### ADDENDUM A Staff Report: Z-72-25-6

Proposal: Commercial Uses

**Location:** Northeast corner of 17th Street and

The purpose of this addendum is to revise the language for Stipulation No. 1 to reflect updated elevations submitted by the applicant.

Elevations date stamped August 18, 2025

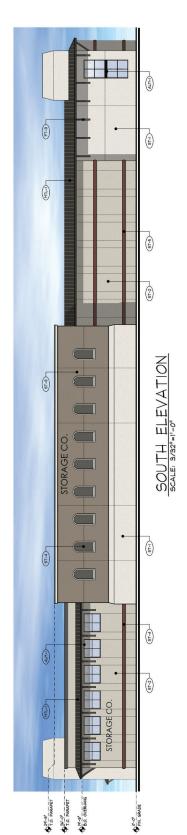
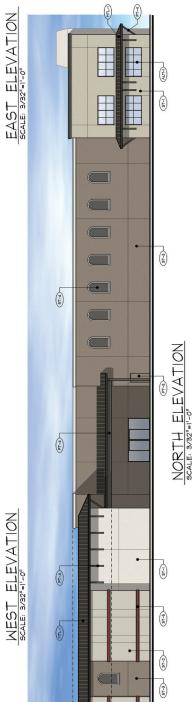
The North Mountain Village Planning Committee is scheduled to hear this case on August 20, 2025. On August 18, 2025, the applicant submitted revised elevations to reflect ongoing discussions with community members. The revised elevations depict a color scheme that contains natural earth tones. Staff recommends modifying Stipulation No. 1 to reflect the new submittal date and to ensure the elevations develop as proposed.

- 1. The development shall be in general conformance with the site plan and elevations date stamped May 27, 2025, AND THE ELEVATIONS DATE STAMPED AUGUST 18, 2025, WITH SPECIFIC REGARD TO THE COLOR PALETTE, as modified by the following stipulations and approved by the Planning and Development Department.
